Subject: Beaver Valley Power Station, Unit No. 1
Docket No. 50-334, License No. DPR-66
License Amendment Request No. 297

Beaver Valley Power Station, Unit No. 1
License Amendment Request No.297

Beaver Valley Power Station, Unit No. 1 License Amendment Request No. 297 MASTER CURVE METHODOLOGY

Figure 4.2-1
Reactor Coolant System Heatup
Limitations Applicable for the First 22 EFY (TS 3.4.9.1)

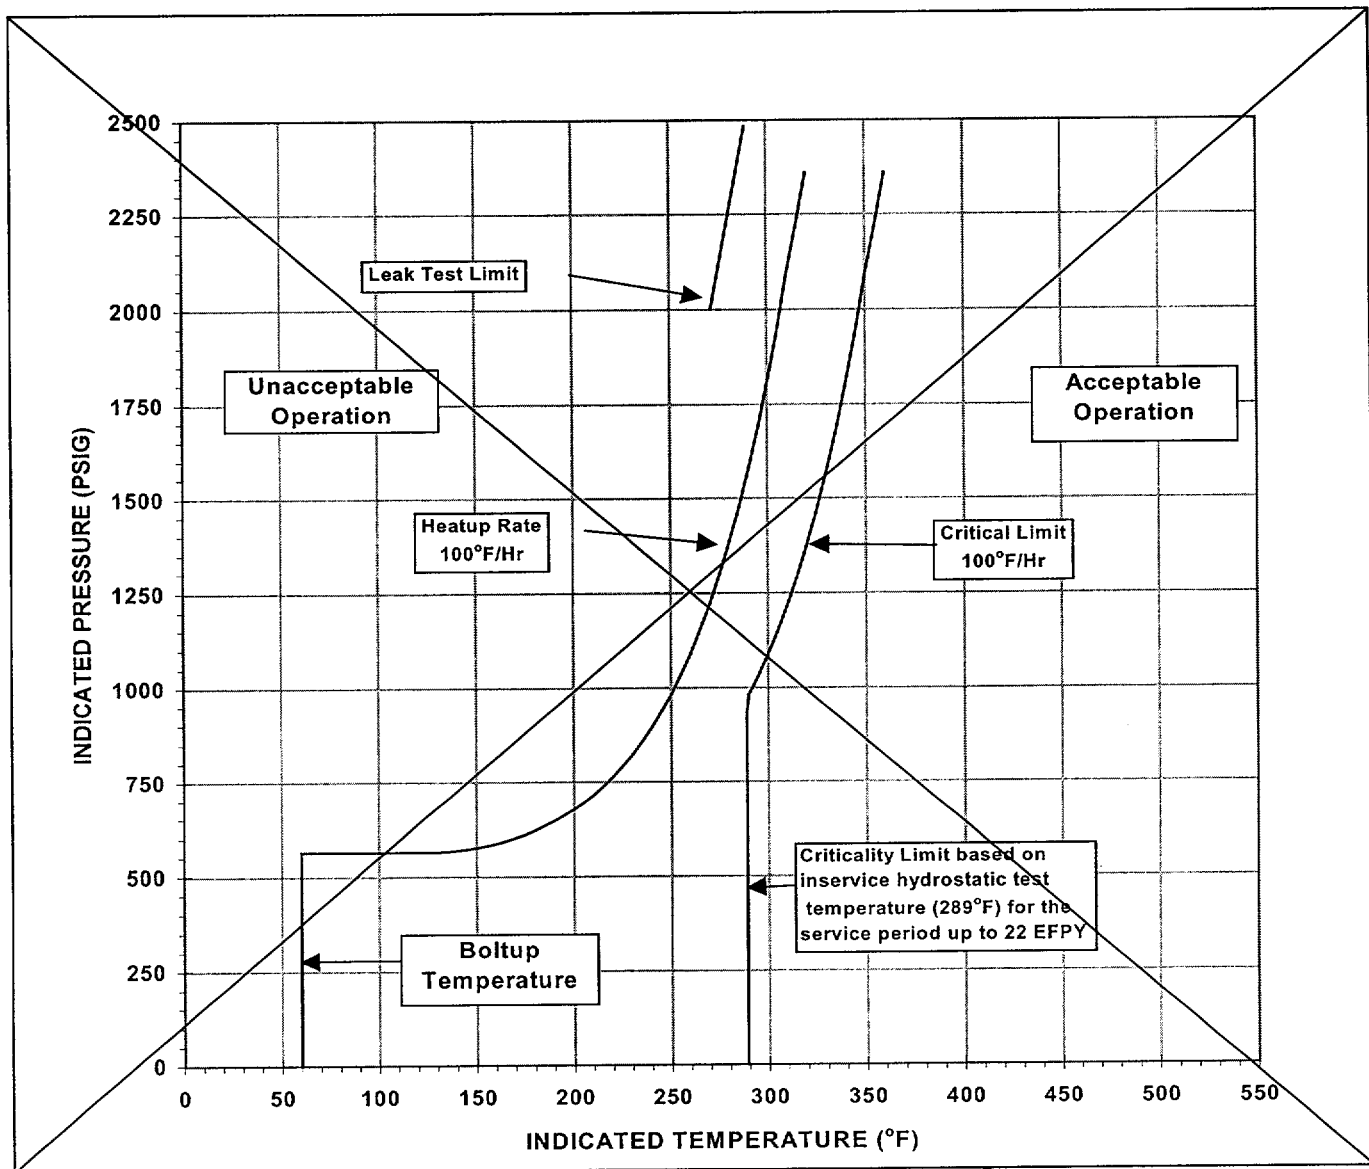
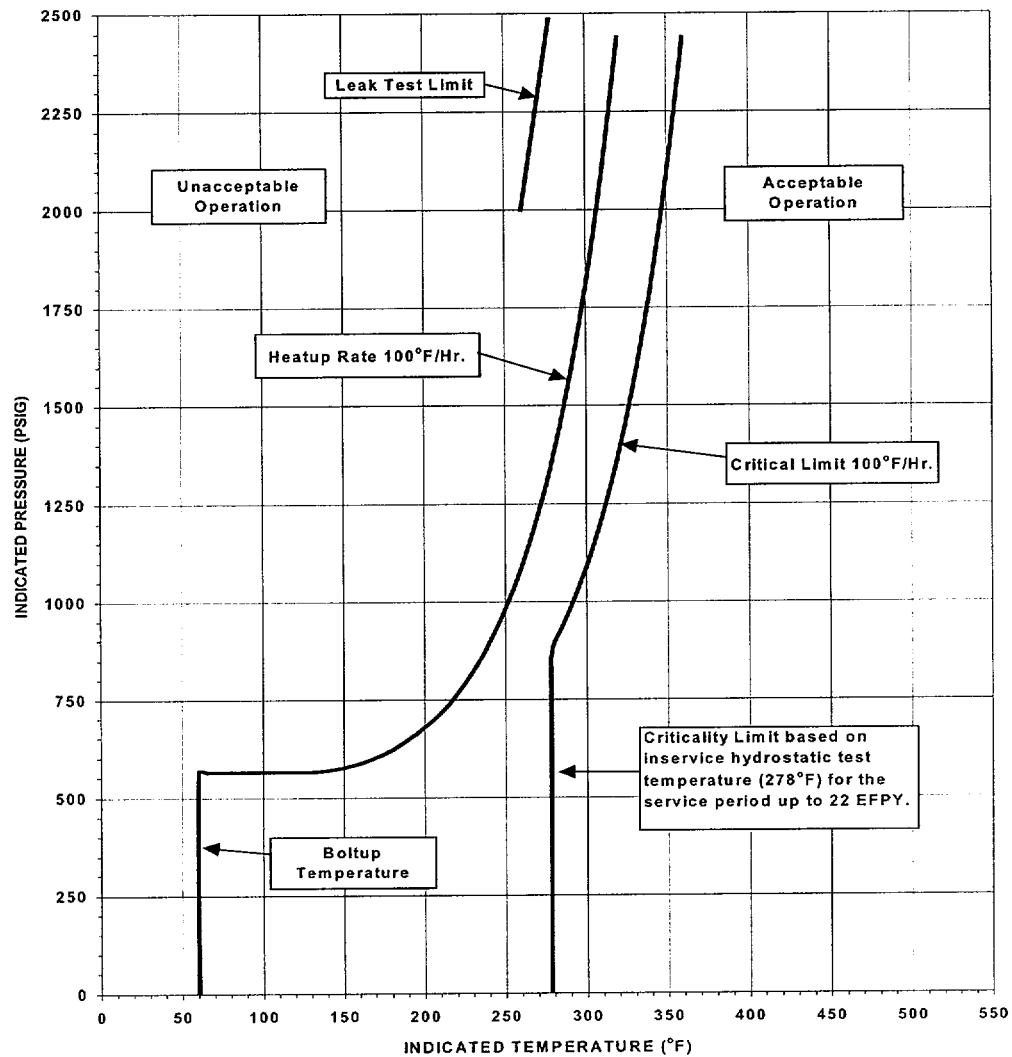
7. PTLR Figures 4.2-1 and 4.2-2 and Tables 4.2-1 and 4.2-2 are revised to be consistent with the Master Curve Methodology.
8. PTLR Table 4.2-3 is revised to reflect the new OPPS enable temperature and PORV setpoint.

LIMITING ART VALUES AT 22 EFY: 1/4T, 233222°F

Replace with Insert A-1

Insert A-1

Figure 4.2-2
Reactor Coolant System Cooldown
Limitations Applicable for the First 22 EFPY (TS 3.4.9.1)

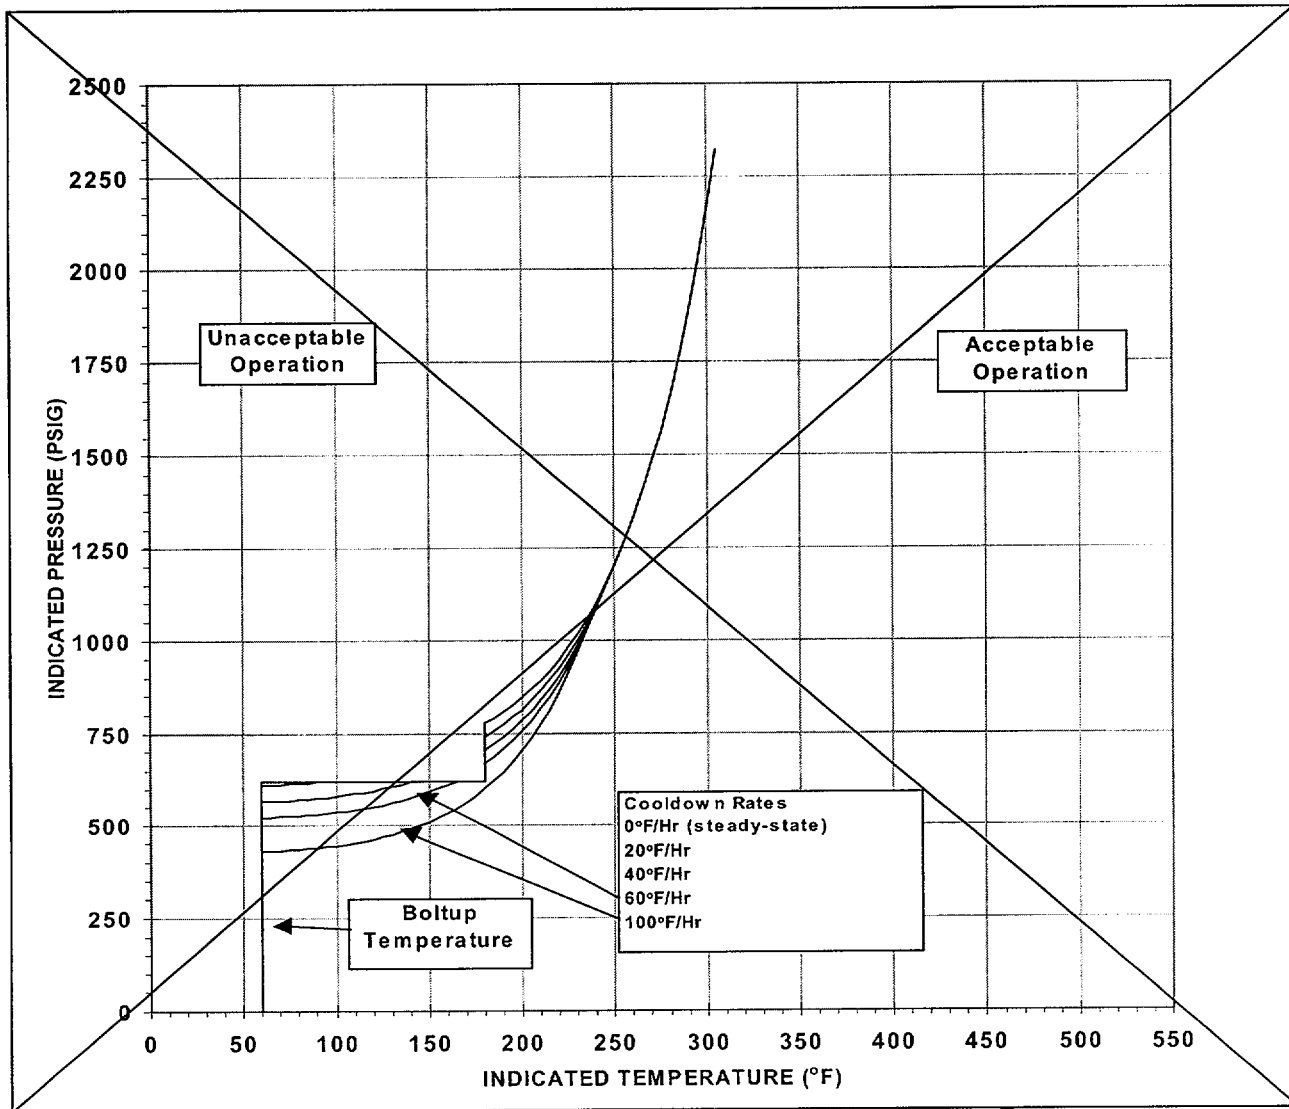
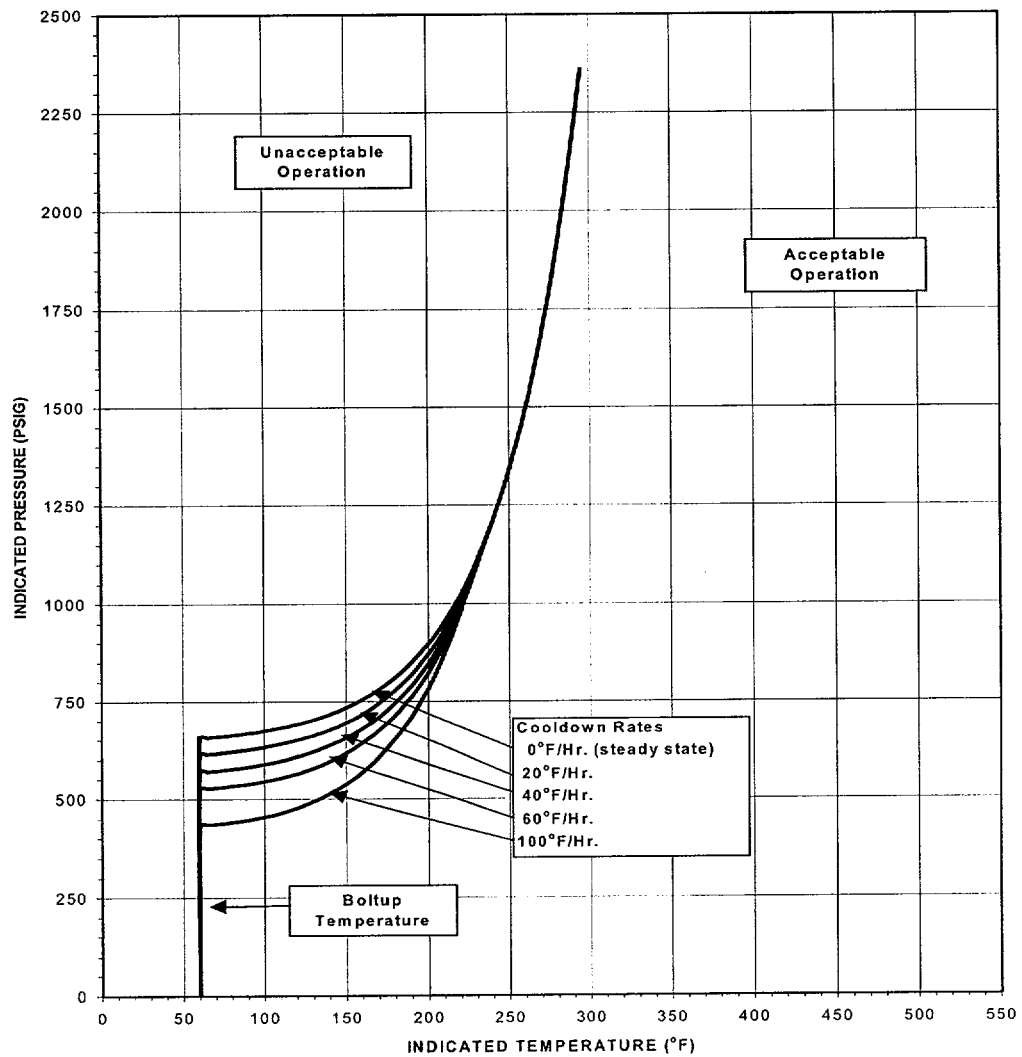
LIMITING ART VALUES AT 22 EFPY: 1/4T, ~~233~~222°F

Replace with Insert A-2
